# New Project Proposal: SFF-TA-1033

Presentation Date: March 22, 2024

# New Project Proposal: SFF-TA-1033, updates to Rev 1.0

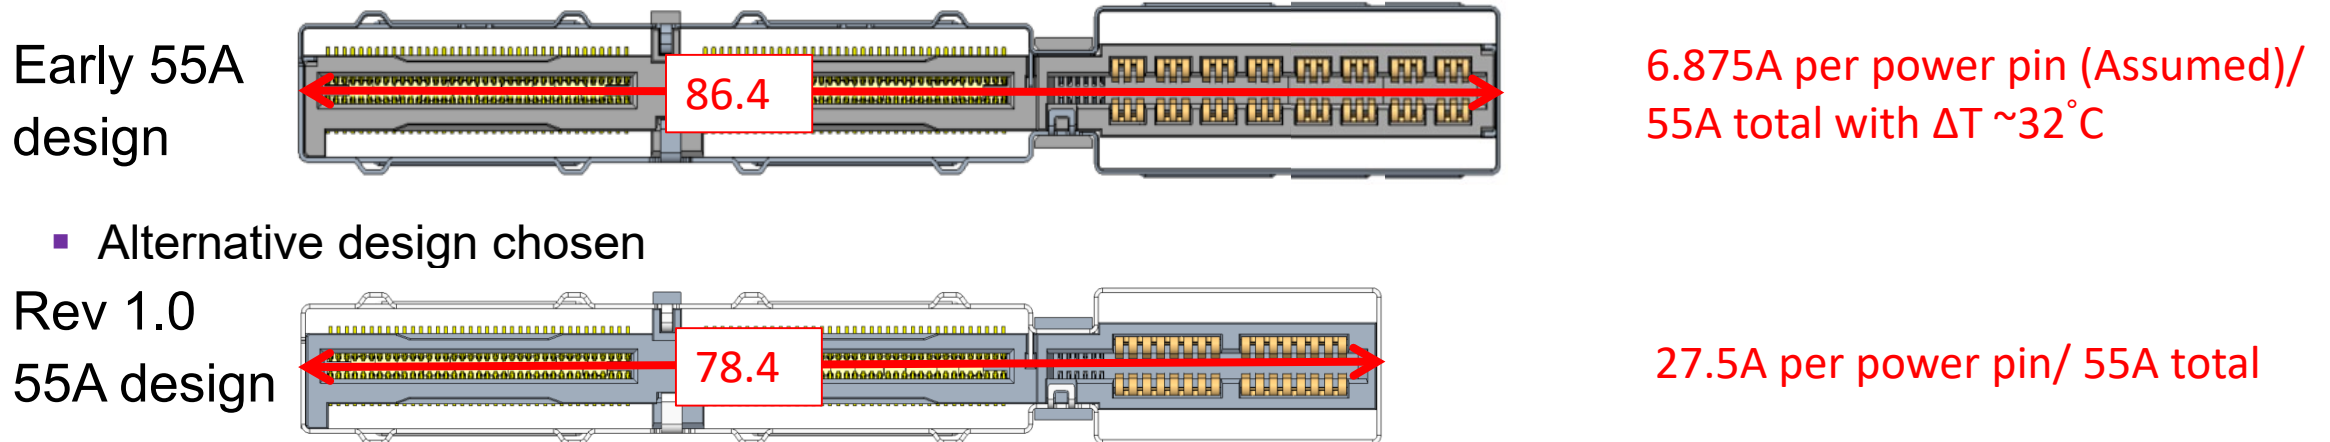
- Connector length, 86.4mm, was considered too long – would require stricter SMT reflow process.
- T-Rise will exceed 30°C. To control within 30°C, we might need more CU layers to support.

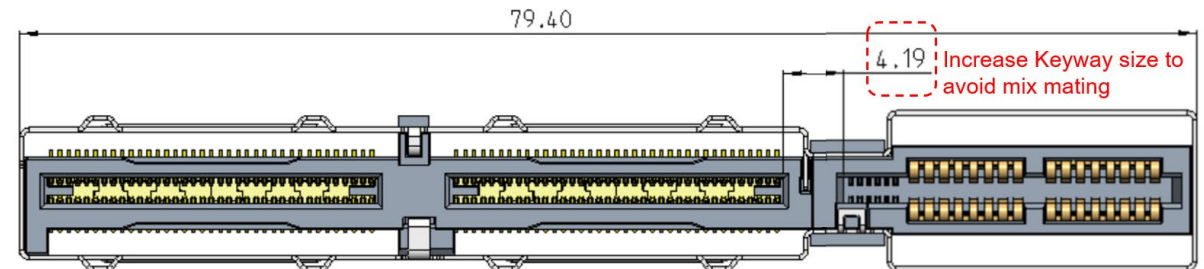
## ■ Issue with current 55A design

- In addition to mating plugs, these connectors can also accept an AIC.
- What if someone plugs in an AIC expecting 21A or plugs in an AIC expecting 34A into the 55A connector?
  - Bad things can happen.

## ■ Solution:

- Increasing the keyway between the high speed signal portion of the connector and the sideband & power portion of the connector by 1mm will prevent unwanted AICs from accidentally plugging into the 55A connector.

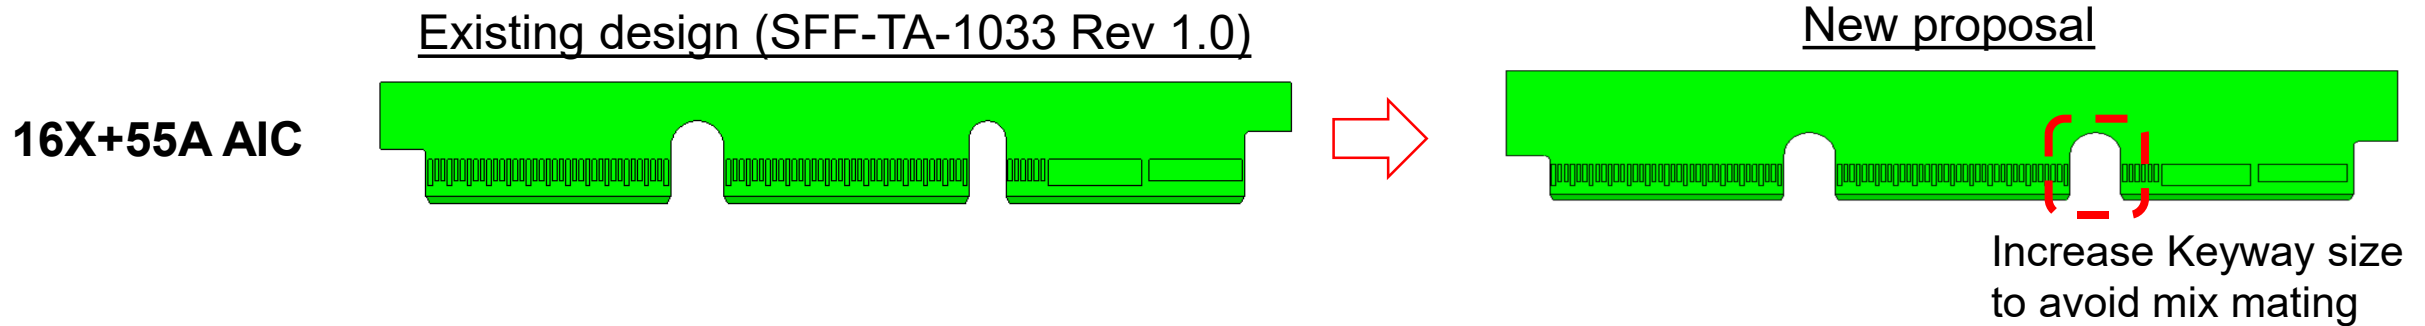
- To go along with the proposed 55A connector key width change, a change to the 55A AIC keyway width is required.

- The same keyway width modification will be needed for the 55A plugs to maintain compatibility.
- Will add some text in Rev 2.0 to highlight incompatibility with the Rev 1.0 55A plugs, AICs, & connectors. Will also add warning notes for the mating matrix conditions indicated in yellow on slides 10 & 11 of this presentation.

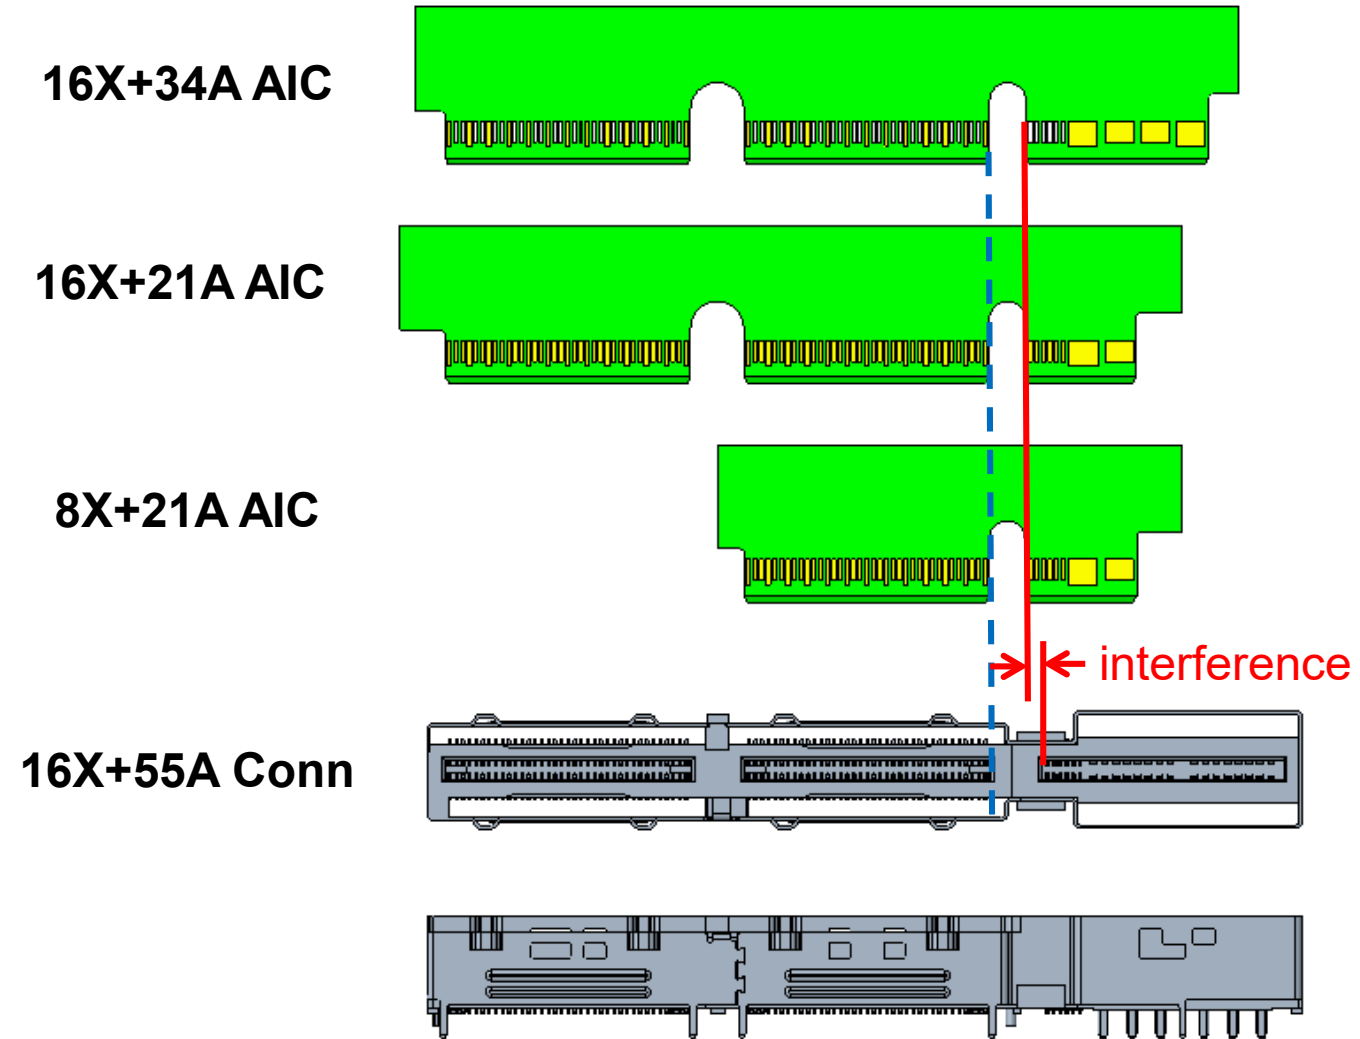
## ■ Mix Mating Avoided ...

- AIC (16X+34A, 16X+21A, & 8X+21A) cannot be plugged in after the 16X+55A connector key width design change.

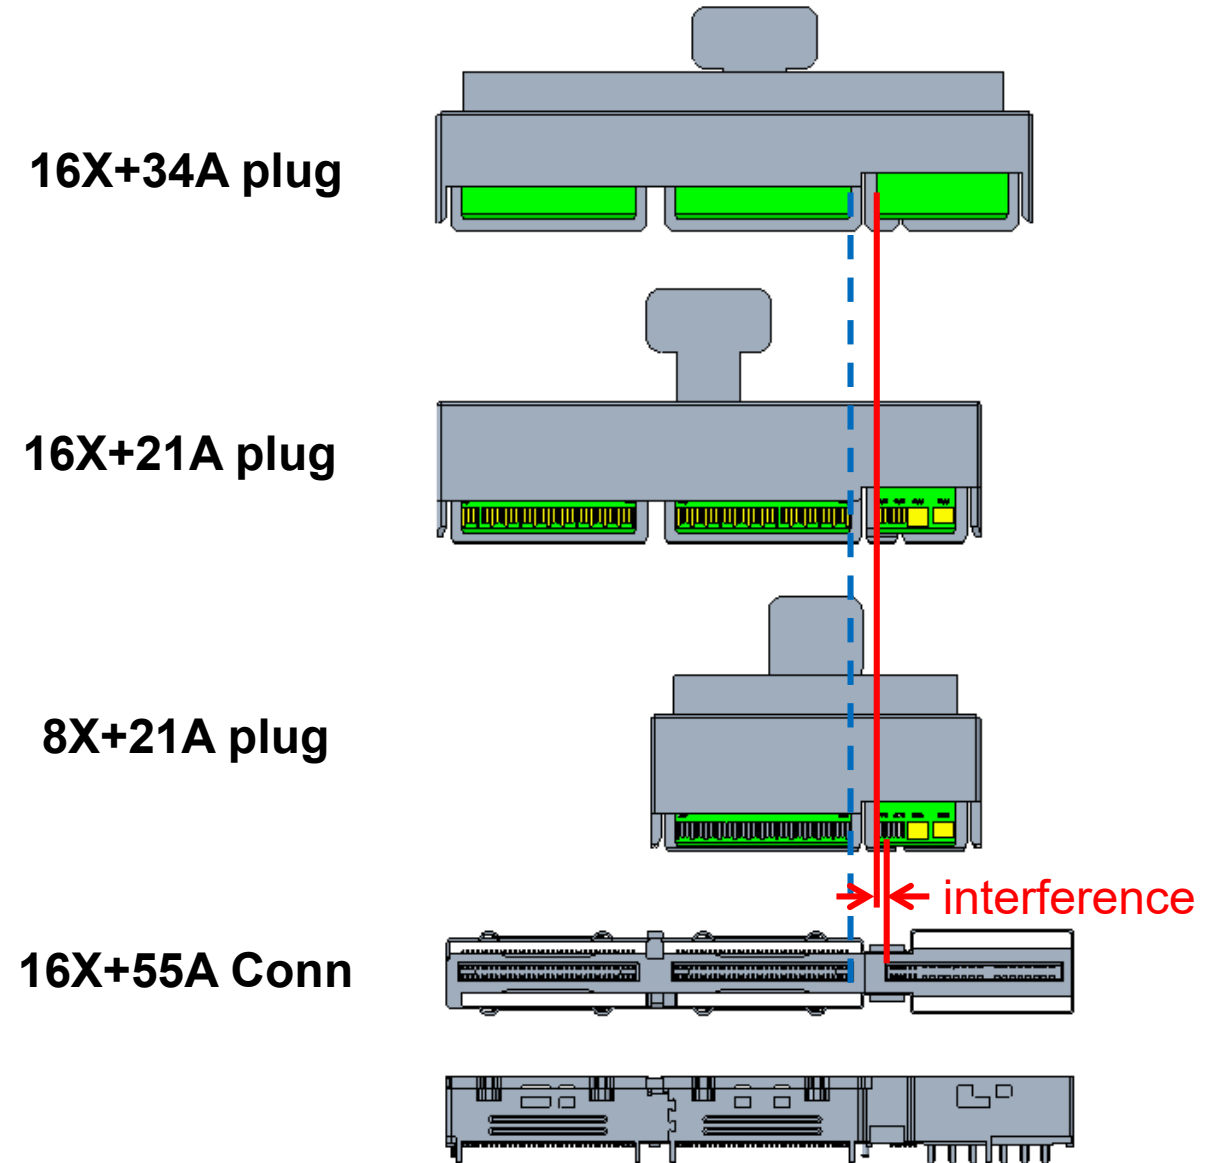
- Cable plug (16X+34A, 16X+21A, & 8X+21A) cannot be plugged in after the 16X+55A connector key width design change.

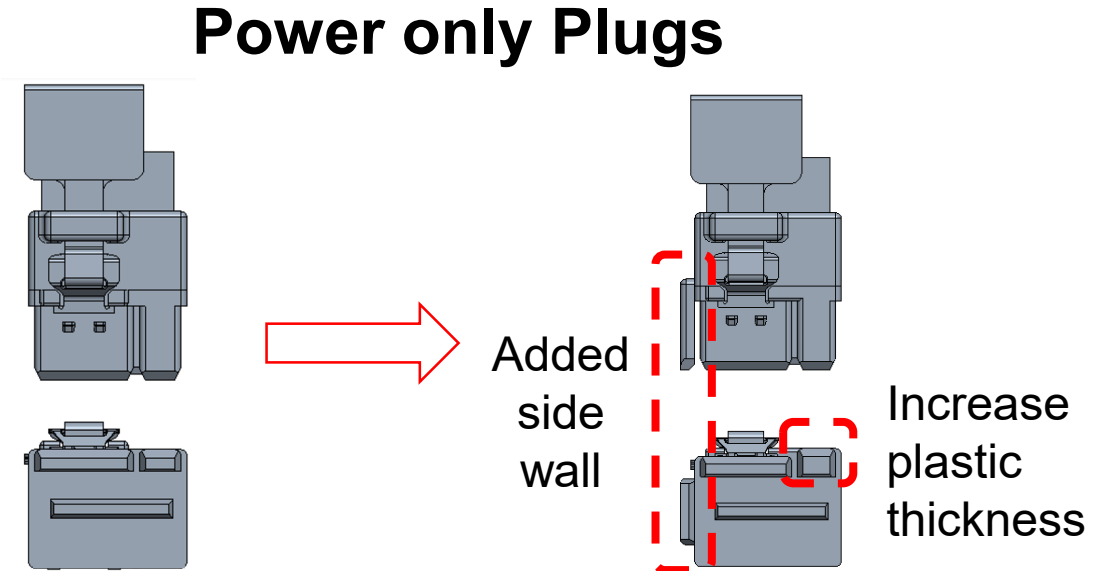
- **Another potential mix mating of a plug connector with the wrong receptacle connector ...**
  - The Rev 1.0 lower amperage power-only Power Plugs could potentially plug into the 55A receptacle connectors, which could have bad results.
- **Solution:**
  - Add a side wall to the power-only Power Plugs to prevent plugging into the wrong receptacle connector.
  - Increase the plastic thickness of an existing wall to cause mating interference when trying to plug into the wrong receptacle connector.

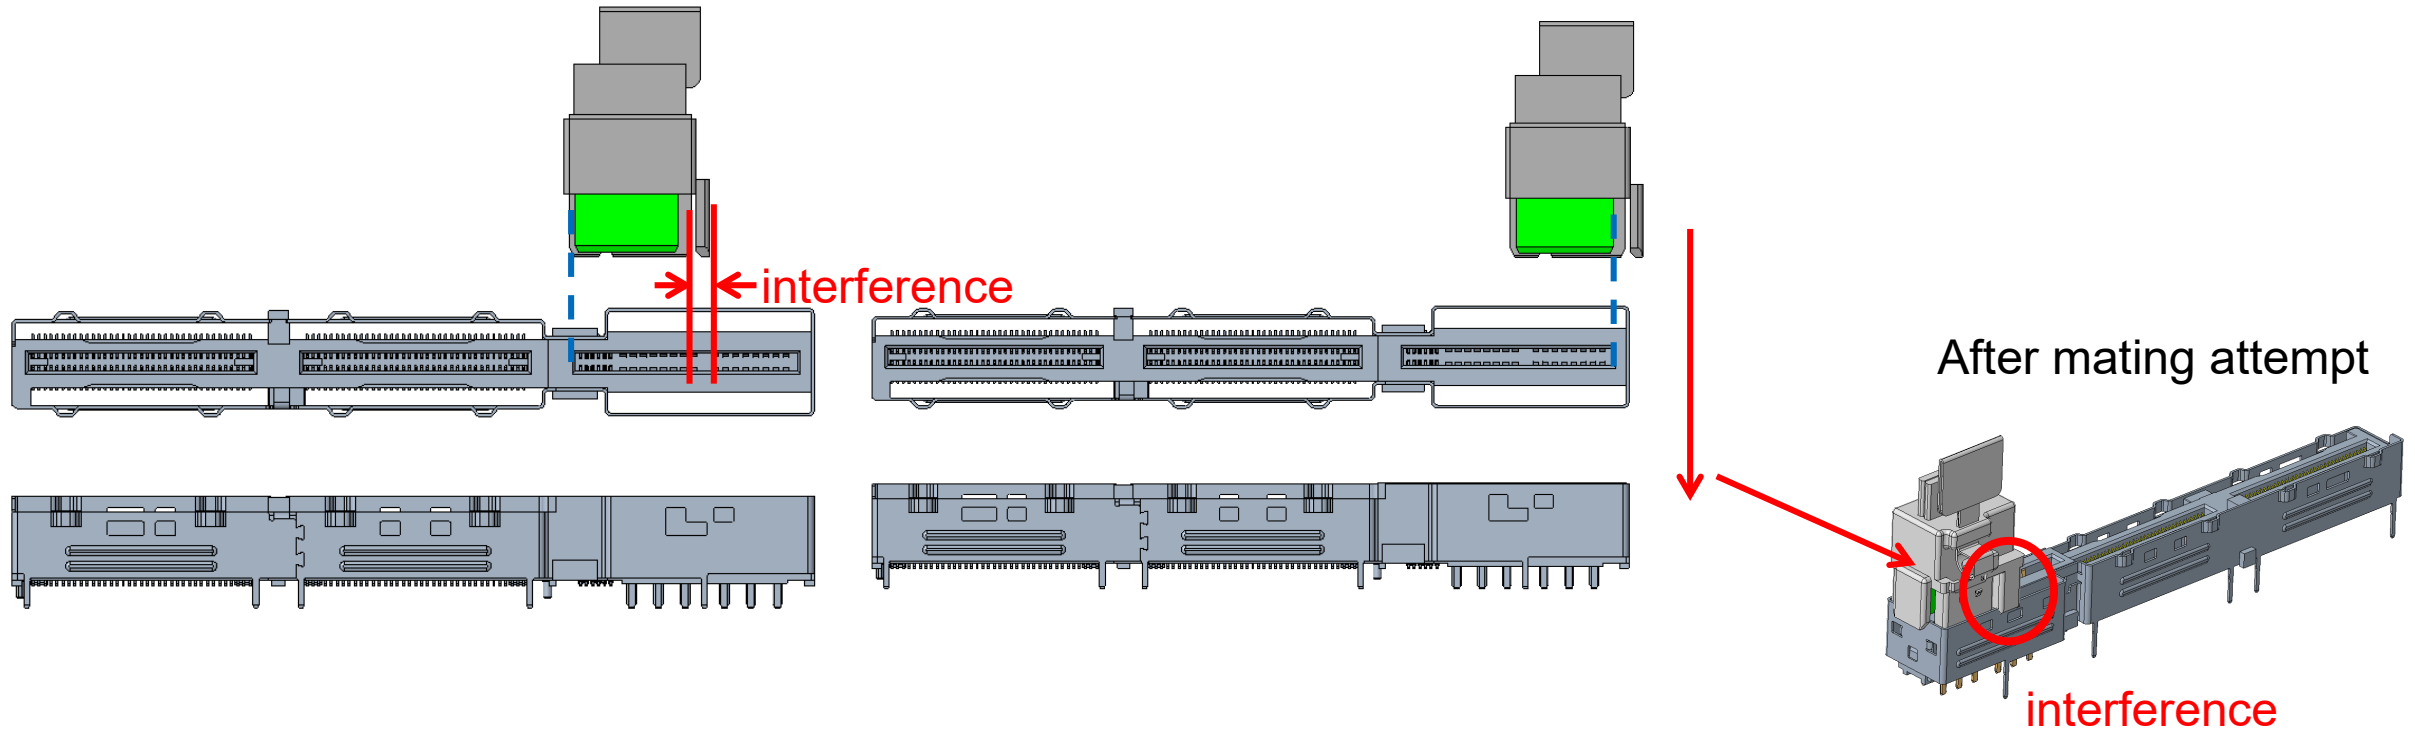
- Power Plug cables cannot be plugged into the 16X+55A connector after the Power Plug design change.

## ■ Corrections to 21A Power AIC (Figure 6-27)

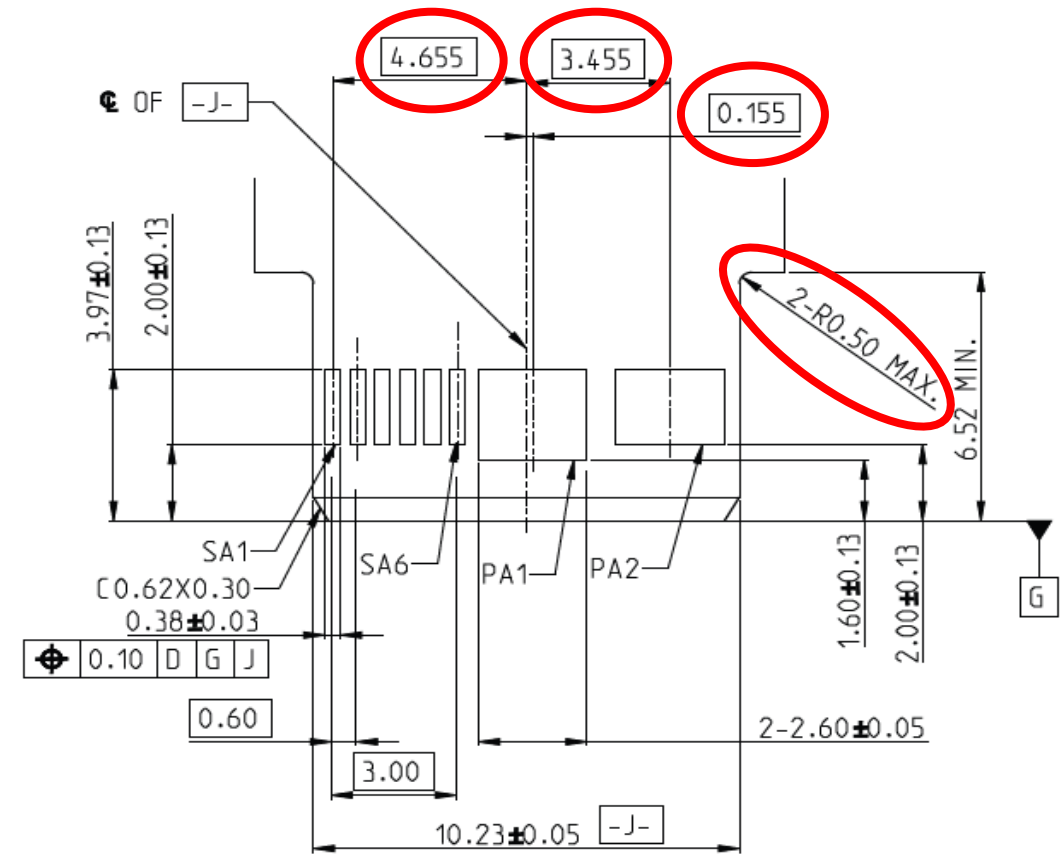
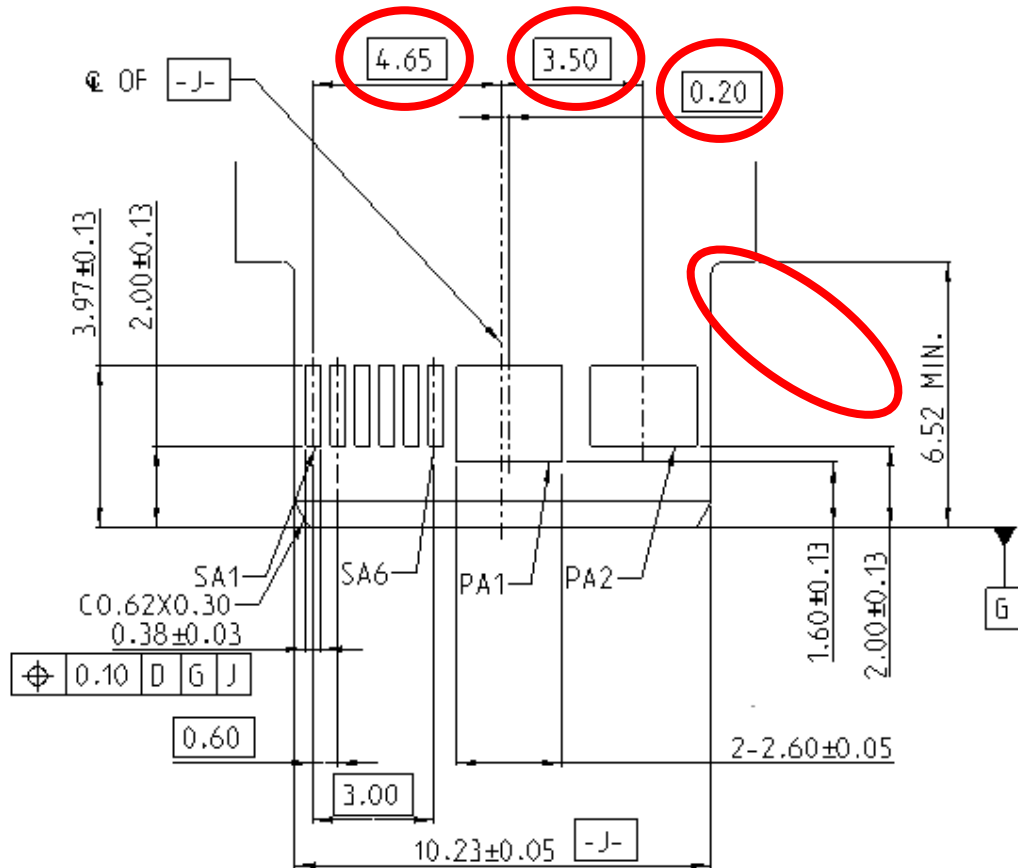
- Modify pad location dimensions from Datum J, as show below
- Add missing radius dimension, as shown below
